January 15, 1997
BYR 97-002

Subject: YNPS Reactor Pressure Vessel (RPV) Package Safety Analysis Report (SAR) -
Updated Drawing (Figure 1.2-1)

TITLE:
FIG 1.2-1-YNPS RPV PACKAGE
ELEVATION CROSS SECTION
JOB NO. YR-B-90-005
DWG. NO.

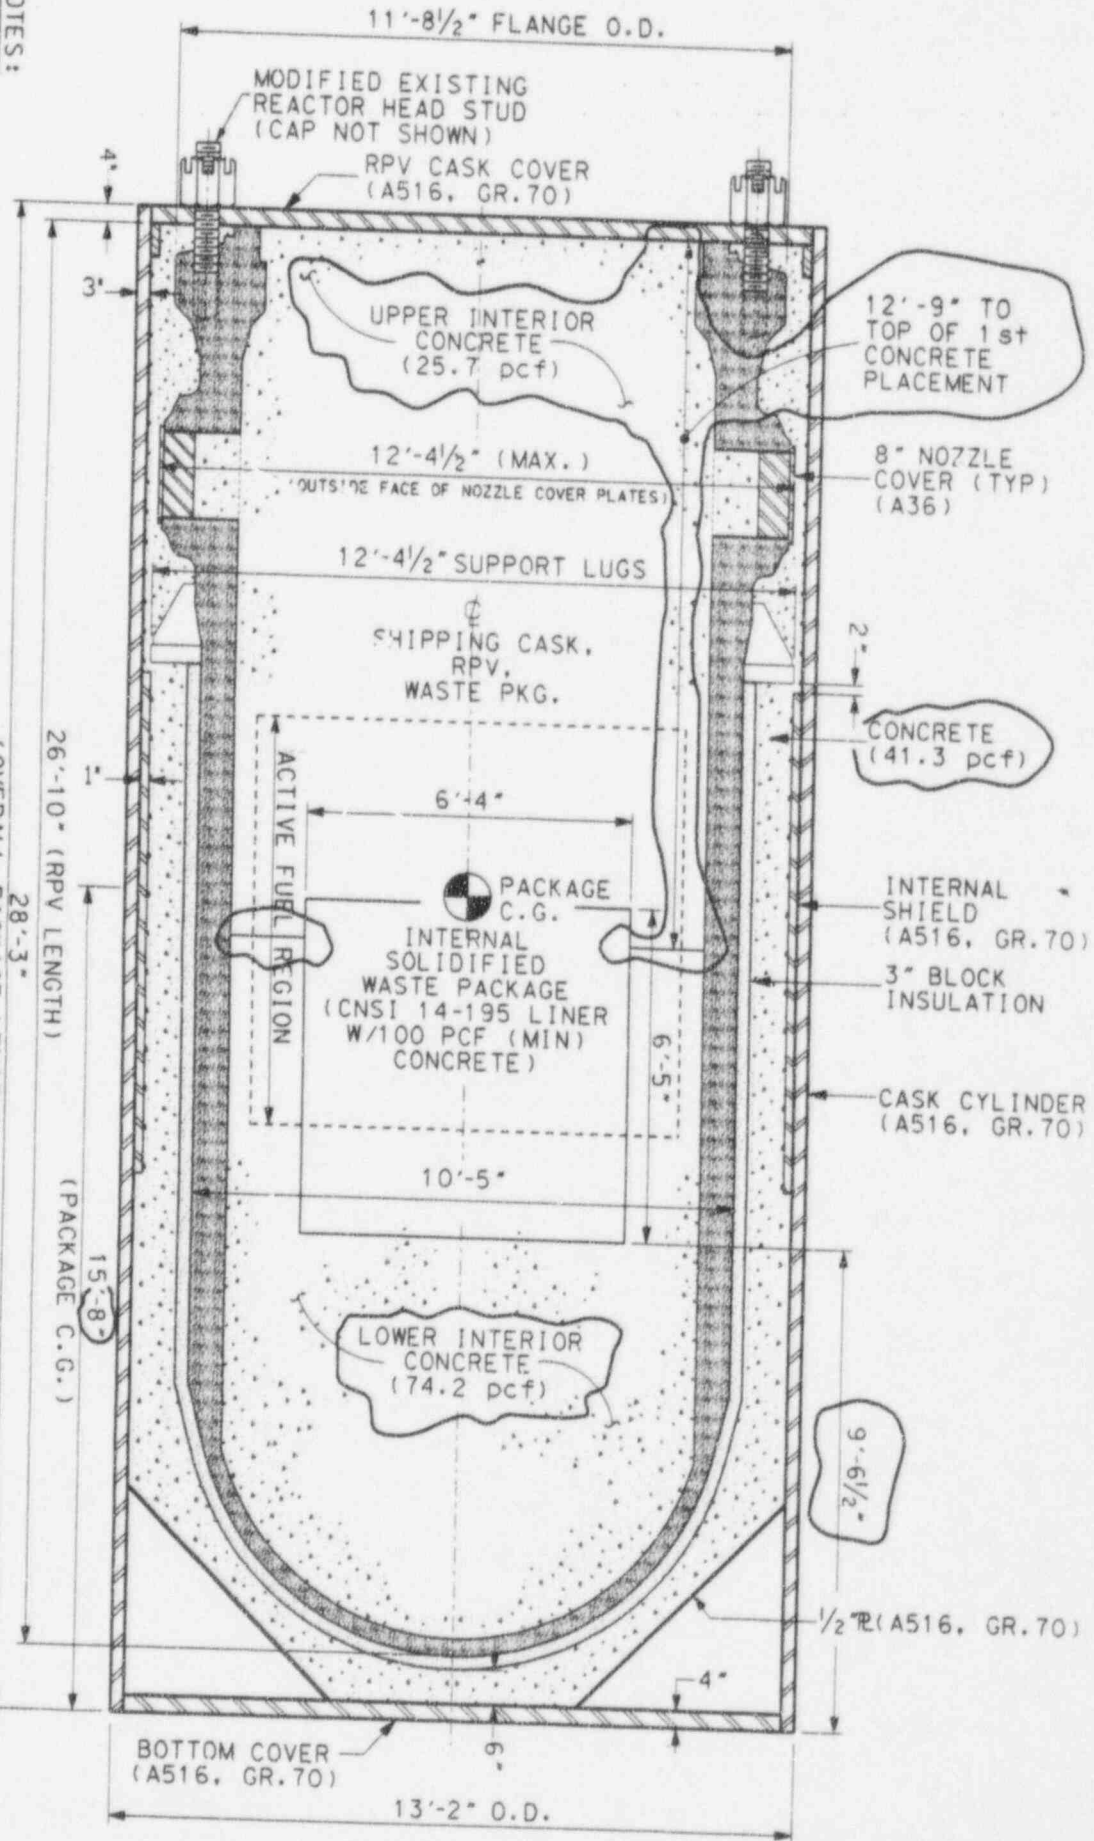
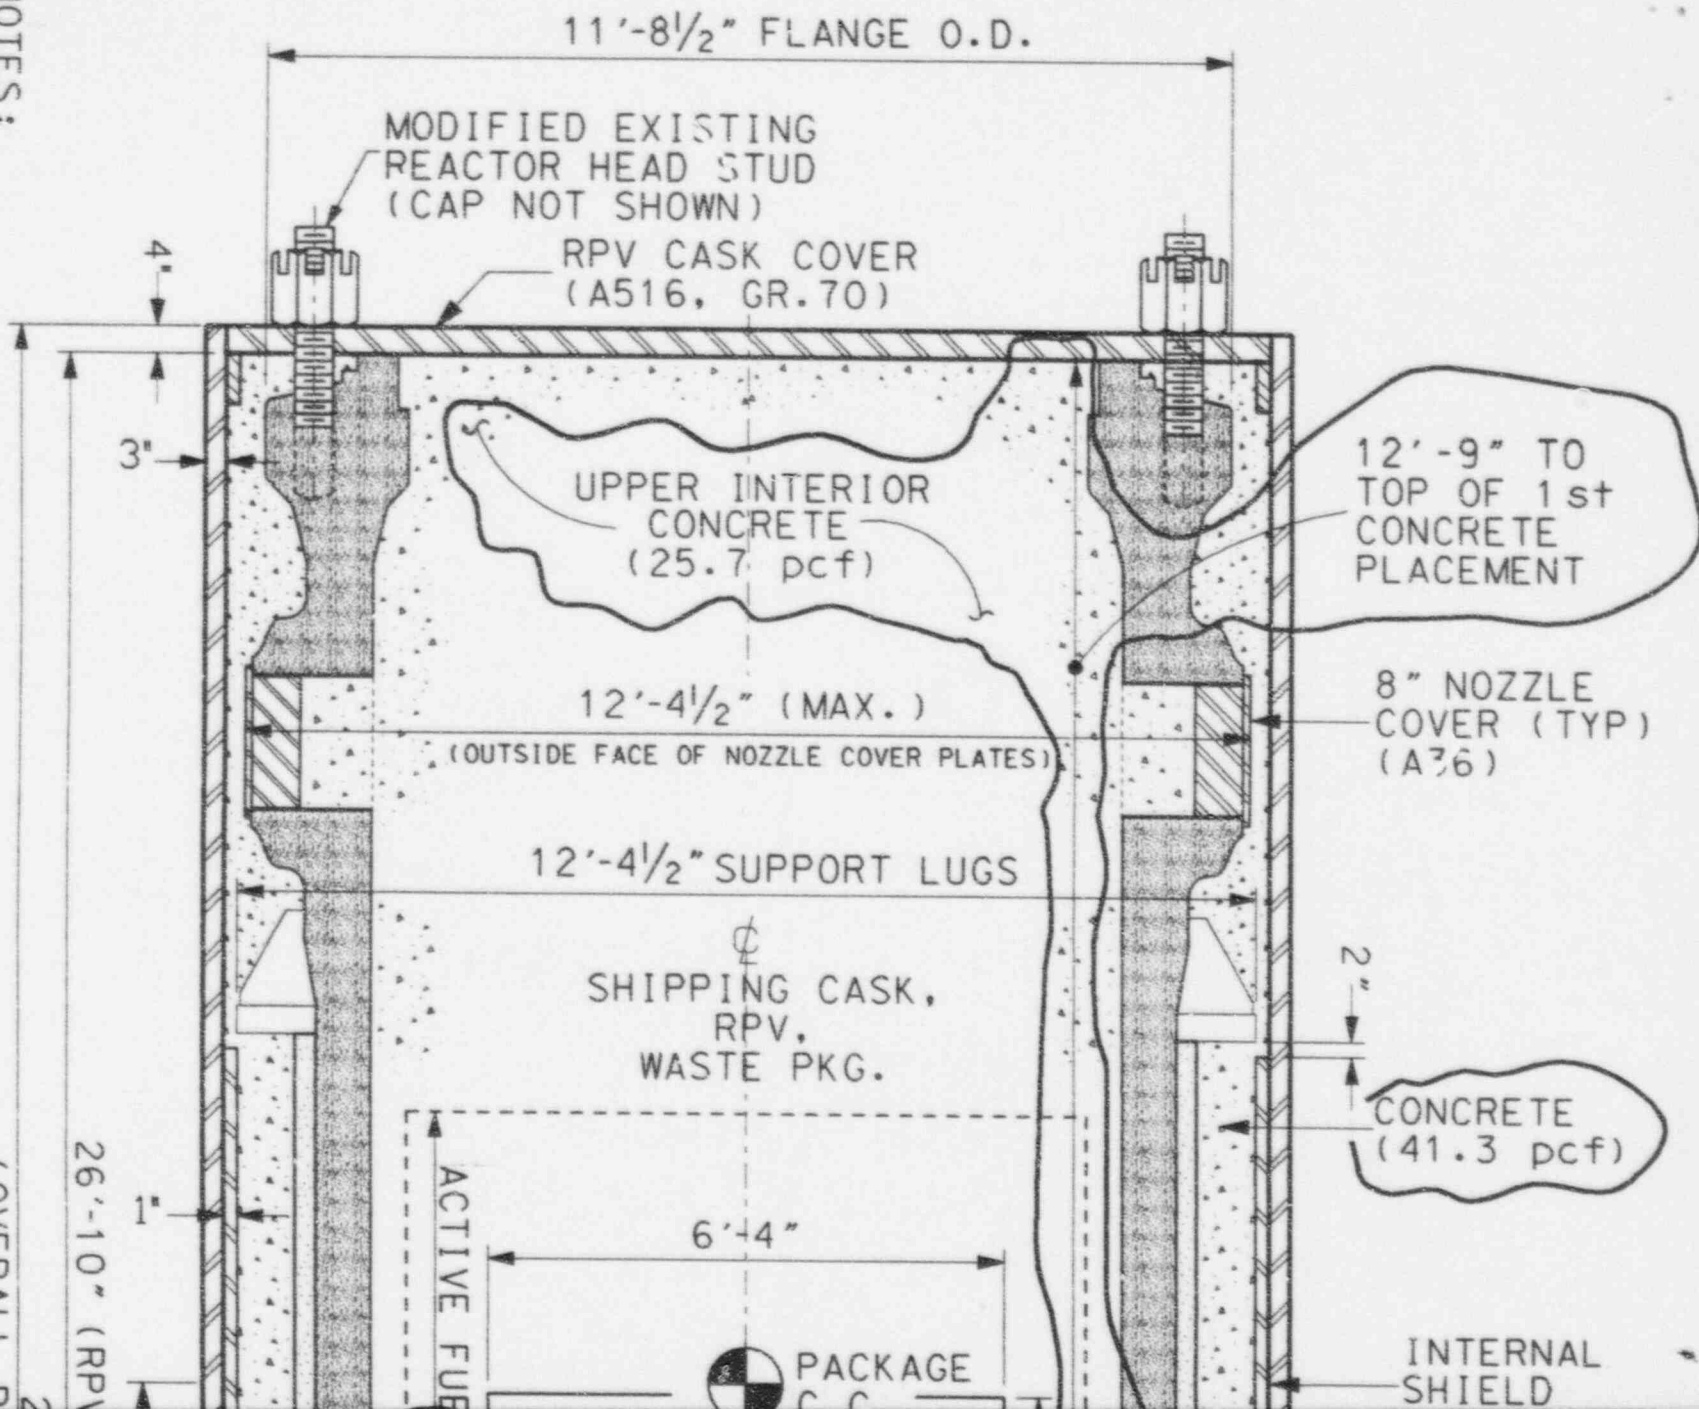
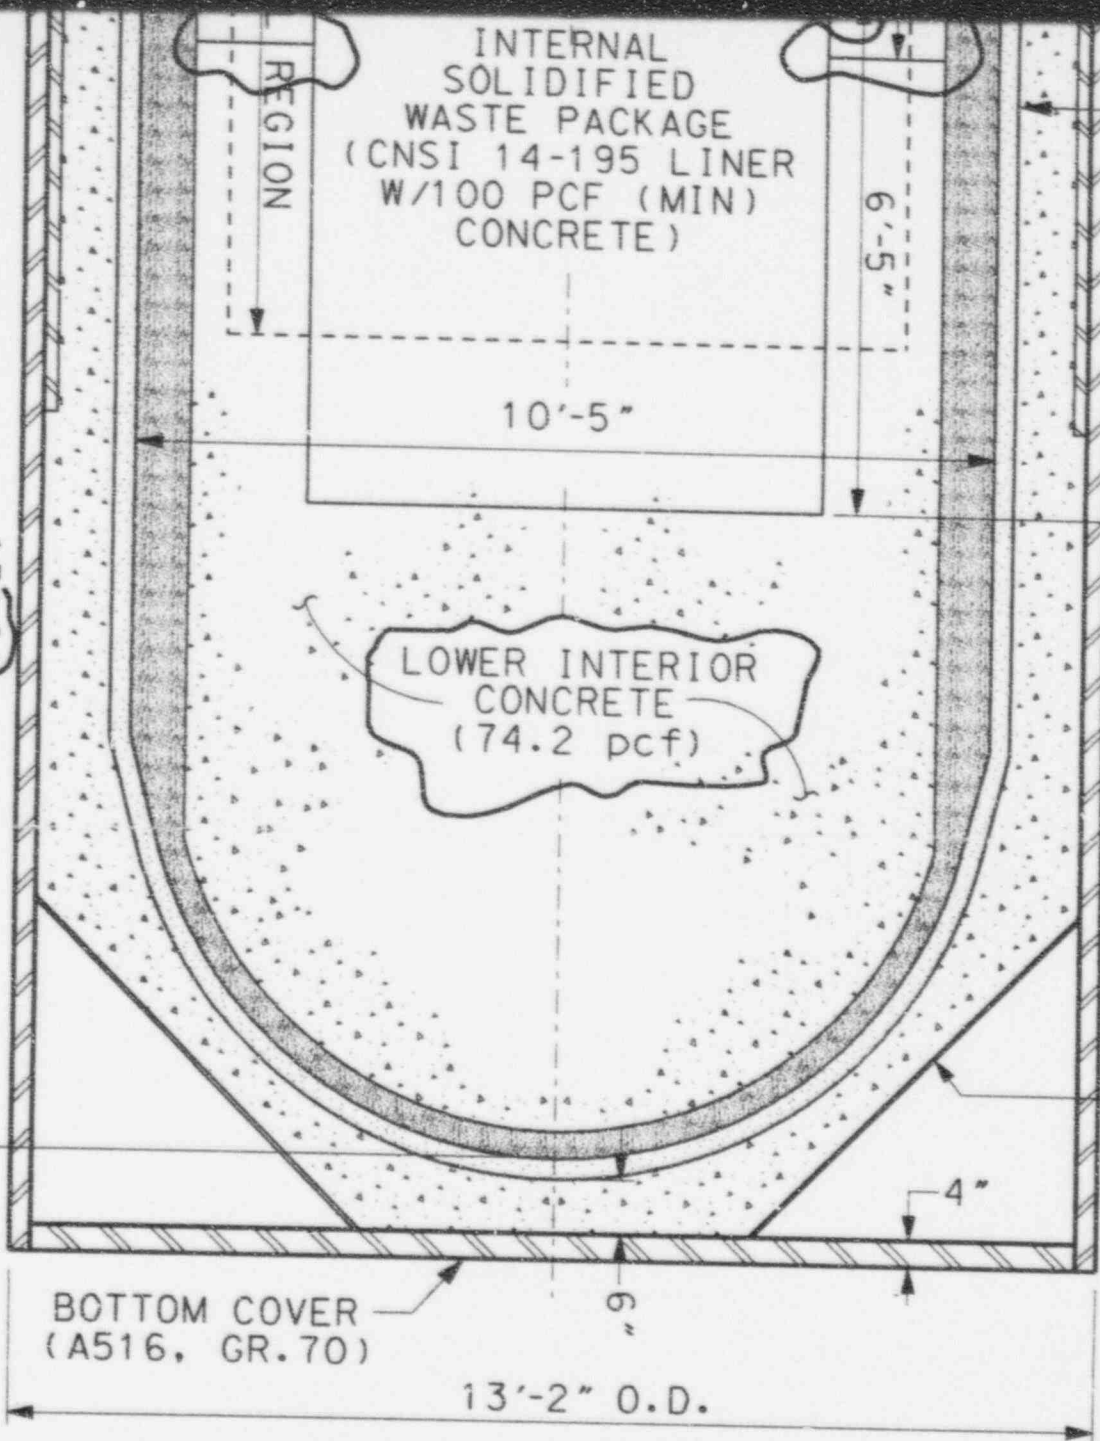
In Reference (d), Yankee submitted a revision of our SAR for the YNPS RPV Package. The purpose of this revision was to present a reduction in density of the non-structural concrete fill. The reduction was necessary to reduce the overall package weight for rail shipment. On November 20, 1996, the reactor vessel was successfully removed from containment and placed into its shipping container. Subsequently, the vessel interior and annulus between vessel and cask were filled with concrete and the top cover welded in place in accordance with the SAR and NRC Certificate of Compliance (Reference (b)). This letter provides an updated drawing, Figure 1.2-1, reflecting the actual concrete density values within the package.

REV	DESCRIPTION	BY	CHKD.	APRD.
3	REVISED TO AS-BUILT	WTT	JAC	JAC
2	REVISED FOR CONCRETE DENSITY AND CLEVIS CHGS.	WTT	JAC	JAC

Based on the actual concrete densities, the resulting package weight is approximately 7 tons less than the projected 328 tons stated in the revised SAR (Reference (d)). Furthermore, based on a survey conducted on January 10, 1997, the package dose rates, both on contact and at 2 meters, meet the limits in 10CFR71.47(a), (c). These limits are 200mr/hr on contact and 10 mr/hr at 2 meters.

The actual concrete densities have been compared to those used in the revised SAR. Their impact on the thermal and structural analyses is determined to be negligible. The re-analysis presented in Reference (d), both thermal and structural, shows little impact resulting from the reduced concrete densities, primarily due to the small heat source of the package and overall strength of the package. The thermal performance of the package continues to meet the requirements of
